Comment (Page 170, Line 10, Clause 145.2.10)

This comment is marked UNB_REQ.

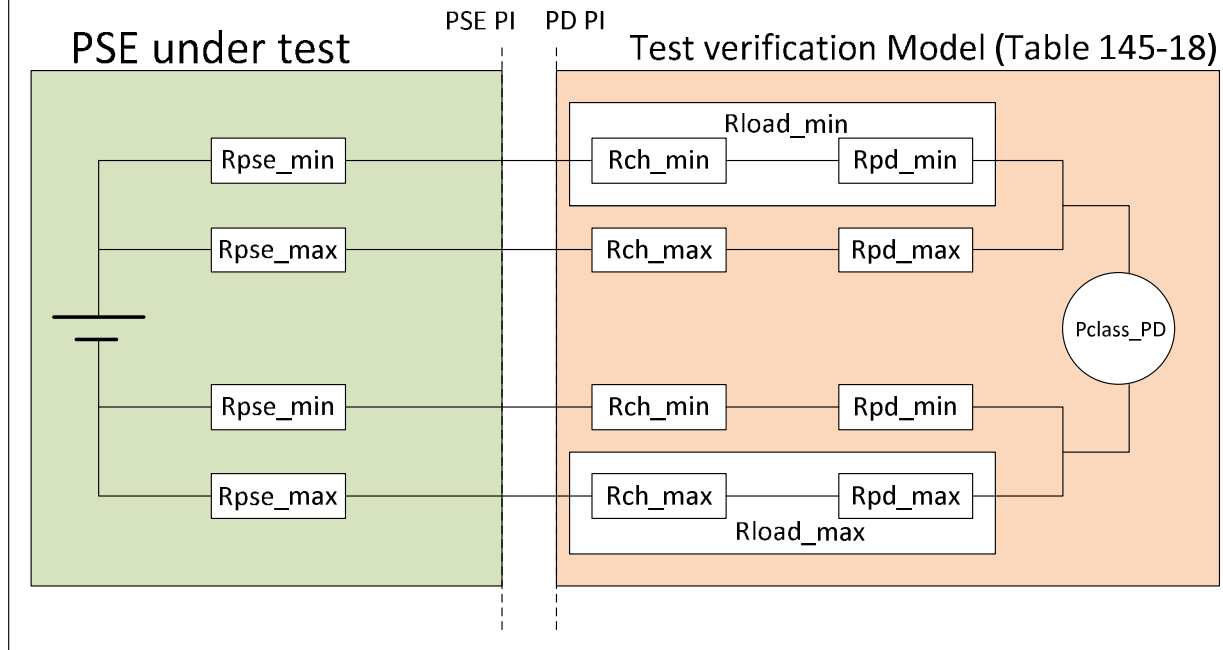
As a result, when connecting the PSE to the test verification model, we will fail lunbalance-2P in Class 5,6 and 7 and 8. The reason for the failure:

Eq-1: Icon-2P_unb=sim_results + 5mA.

Eq-2: lunbalance-2P = Icon-2P_unb - 10mA = sim_results + 5mA - 10mA =sim_results -5mA

→ Actual sim results < lunbalance_2P spec value → failing the test. The worst-case SIM result is the minimum spec value for lunbalance-2P. (and to add to the other margin in the next tables.

4-Pair model used to derive the spec numbers

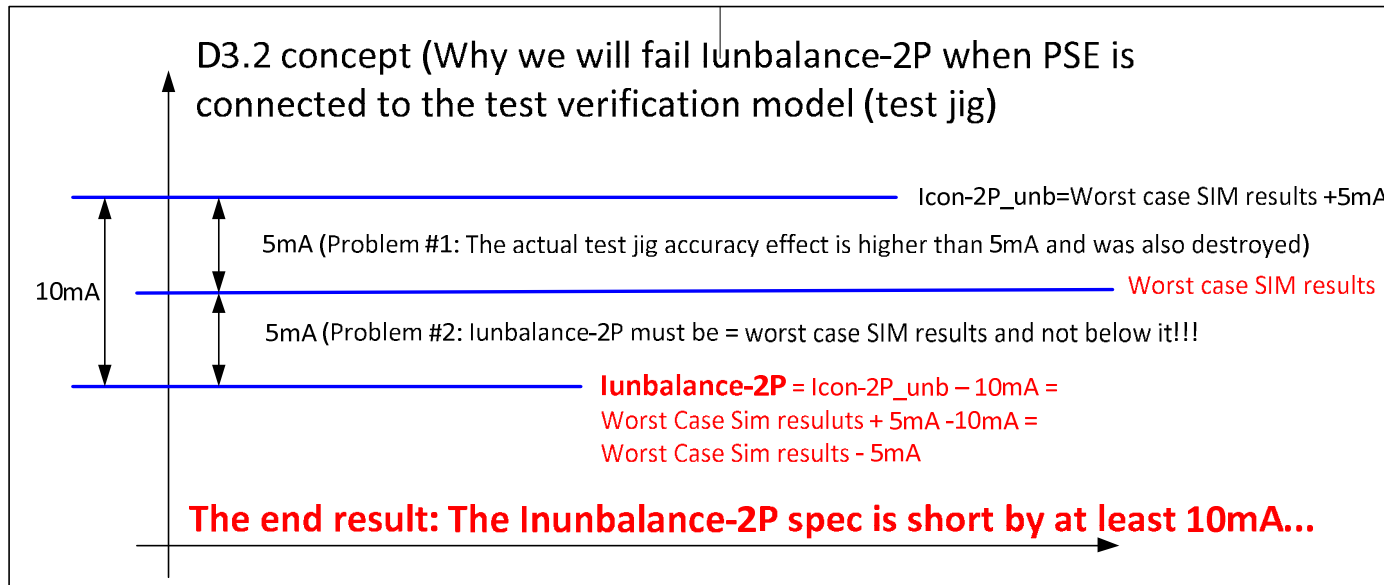
- The above is our 4-pair model used to derive the PSE and PD equations and I_{max} at worst case unbalance conditions.
- It is impossible that if the sim results for class 5 $I_{max}=0.5493A$ we will pass the $I_{unbalance-2P}$ test $=0.455A!$
- We must pass the test for all PSE operating range from 50V to 52V.
- The same problem for all classes.
- For Extended power class 8:
 - The test verification model values of R_{pd_min}/max (which is R_{load2_min} , R_{load2_max} in Table 145–18) are not valid for this case.
 - Equation 145-26 is not valid. Tighter R_{pd_max}/R_{pd_min} ratio is required.

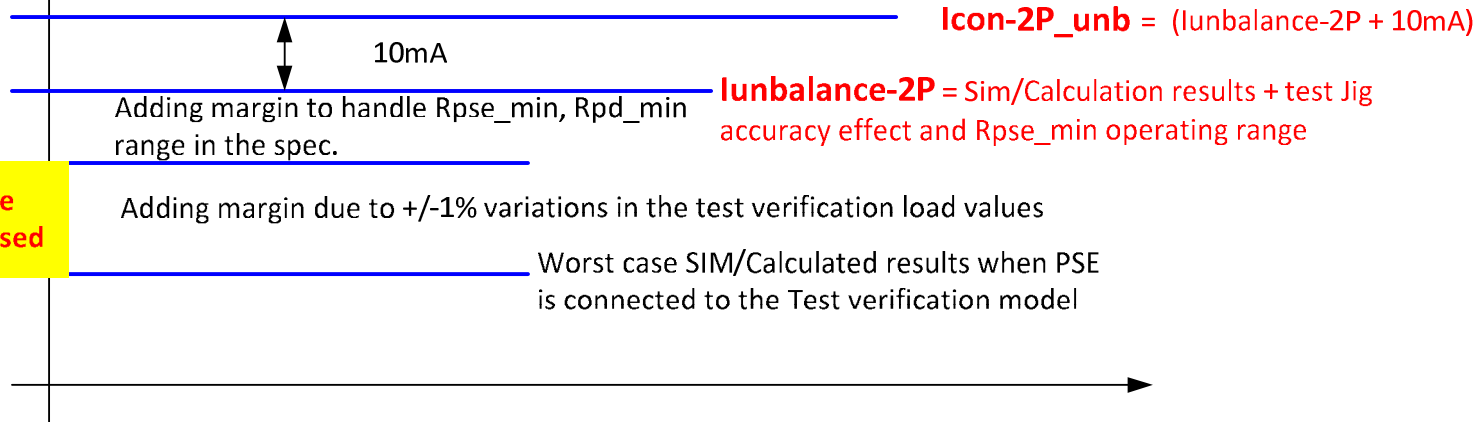
The correct approach is:

1. lunbalance-2P = Worst case sim results + Margins due to test jig component accuracy.
 2. $I_{con-2P_unb} = \text{lunbalance-2P} + 10\text{mA}$
- The margins topic needs a discussion to conclude if we need it and how much we need from it

Propose concept to fix the problem based on actual physics..
